PROJECT: Project Redbird – North Improvements (Phase 2)

SUBJECT: Addendum No. 1

PROJECT NUMBER: SNS-0025

This addendum forms a part of the Contract Documents for the Jefferson County Project Redbird – North Improvements (Phase 2). Contractors are required to acknowledge the receipt of addenda by signing and including all addenda with each bid form. FAILURE TO ACKNOWLEDGE RECEIPT OF ADDENDUM MAY SUBJECT BIDDER TO DISQUALIFICATION.

AIRPORT ROAD
RAILROAD
CROSSING
USDOT #371198H
PROJECT REDBIRD
NORTH IMPROVEMENTS
(PHASE 2)

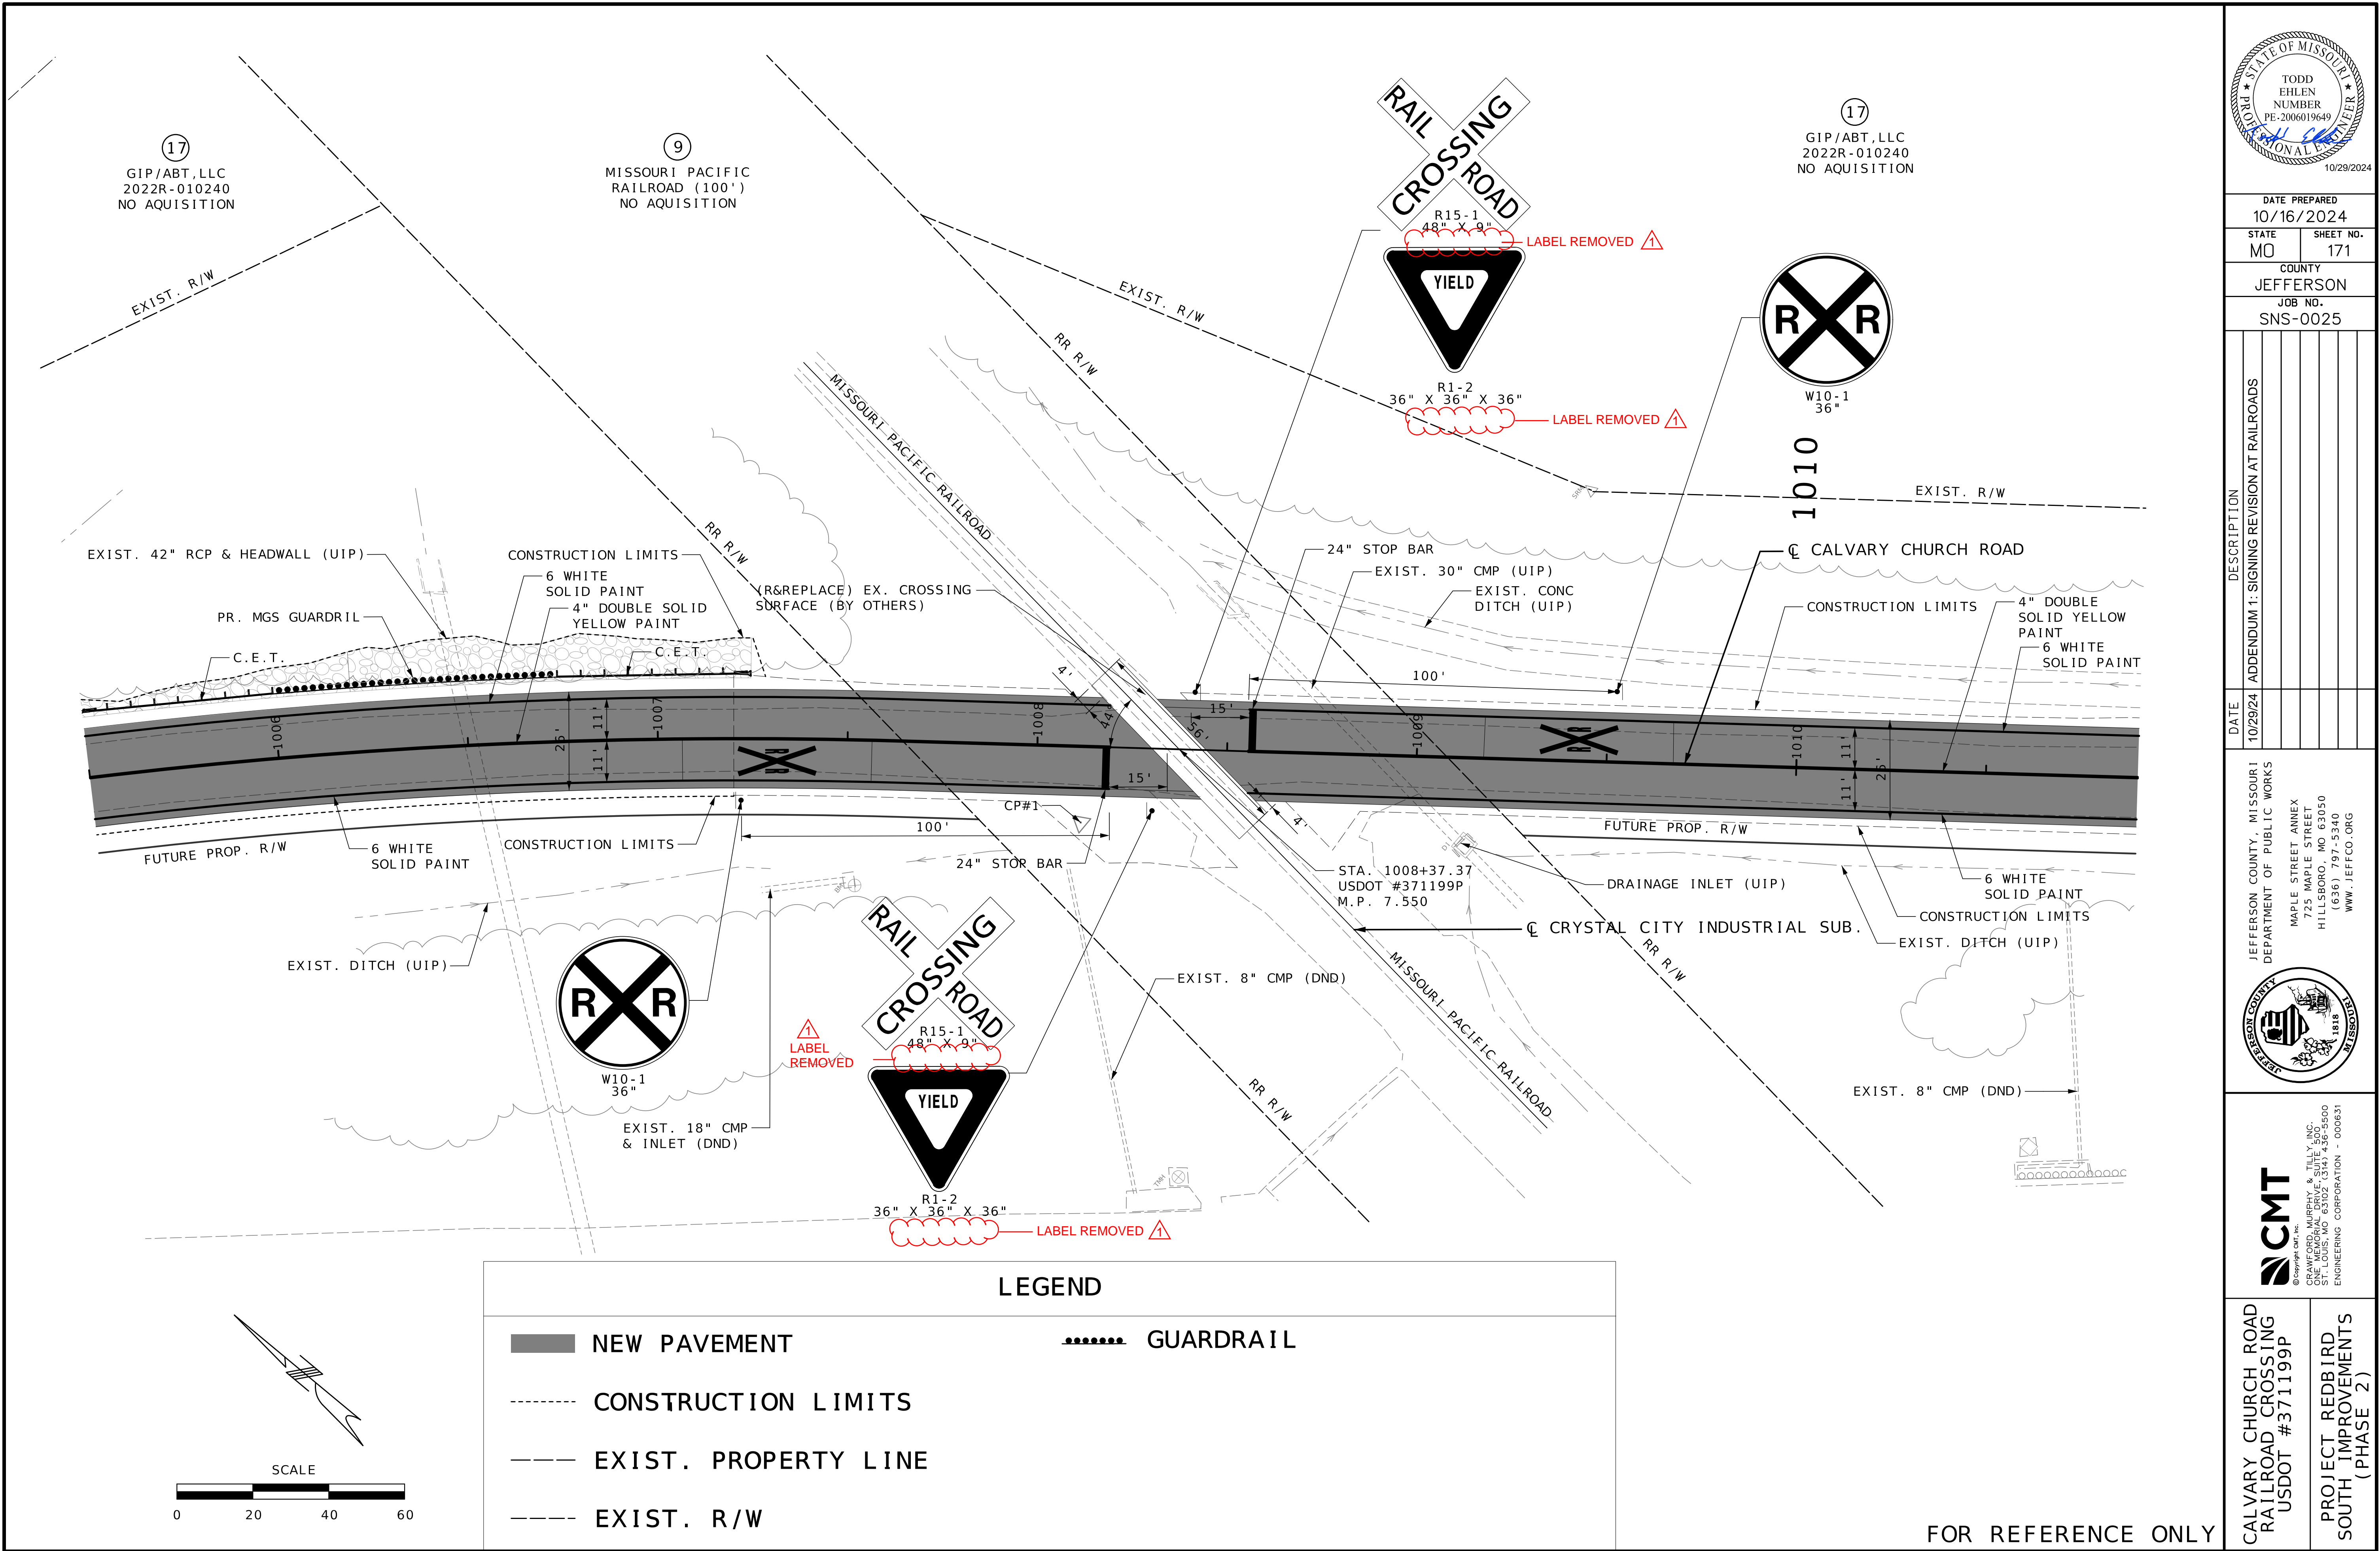
7. Revised Sheet 170 (Airport Railroad Crossing)

Revised callouts with yield and crossbuck sign assembly

- Removed "By Others" from signing callouts
